Subject: Bug in 3K CRAM

REWORK INSTRUCTION FOR CONTROL MODULE WITH 3K CRAM.
(REFER TO FIGURE1)

These drawings and specifications and the data contained therein, are the exclusive property of Xerox Corporation and/or Rank Xerox, Ltd. issued in strict confidence and shall not, without the prior written permission of Xerox Corporation or Rank Xerox, Ltd. be reproduced, copied or used for any purpose whatsoever except the manufacture of articles for Xerox Corporation or Rank Xerox.	Notes Unless Specified		Drawn	Xerox Corporation	XEROX
			Check	El Segundo, California	
	1. Tolerances :xx +.03 Angular .xxx +.010 + 1/2°		Appr.		
	2. Break All Sharp Edges .010 Approx —		Material		
	3. Mach. Surfaces √				
	4. All Dim. in Inches				
					ASSEMBLY, PRINTED WIRING- 3K CRAM

Title
ASSEMBLY, P.W.
3K CRAM

FIGURE 1

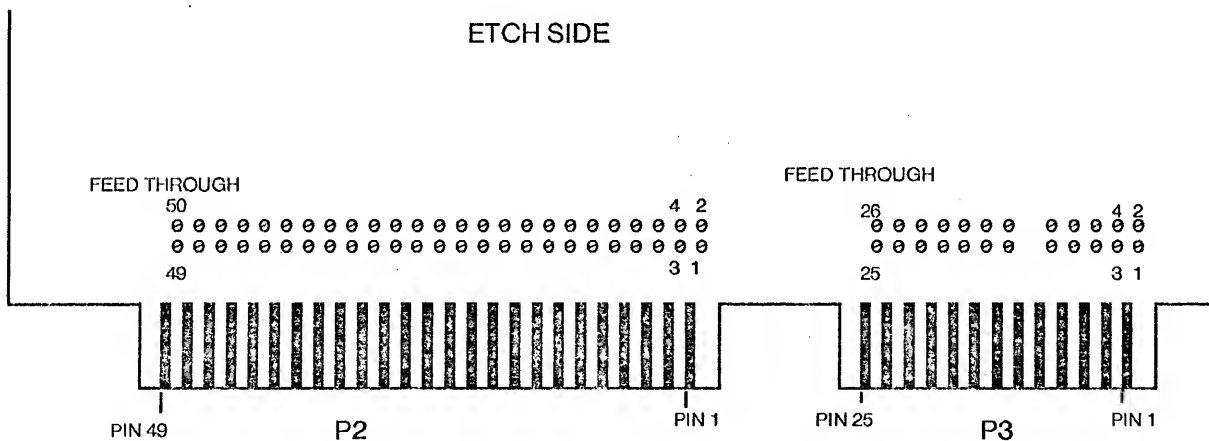
CUT ETCH TO FEED THROUGH P2-14 (ETCH SIDE)

CUT ETCH TO FEED THROUGH P2-12 (ETCH SIDE)

CUT ETCH BETWEEN U51-8 AND U51-7 (ETCH)

CUT ETCH TO U70-10 (ETCH SIDE)

ADD JUMPER FROM U37-12 TO U37-7 (ETCH)

ADD JUMPER FROM U51-7 TO U39-3 (ETCH)

ADD JUMPER FROM U68-9 TO FEED THROUGH P2-14 (ETCH SIDE)

ADD JUMPER FROM U68-12 TO FEED THROUGH P2-12 (ETCH SIDE)

ADD JUMPER FROM U25-11 TO FEED THROUGH P3-7 (ETCH SIDE)

ADD JUMPER FROM U25-3 TO FEED THROUGH P3-8 (ETCH SIDE)

ADD JUMPER FROM U25-4 TO FEED THROUGH P3-9 (ETCH SIDE)

ADD JUMPER FROM U25-6 TO FEED THROUGH P3-10 (ETCH SIDE)

REPLACE U51 WITH SW3K PROM (82S126)
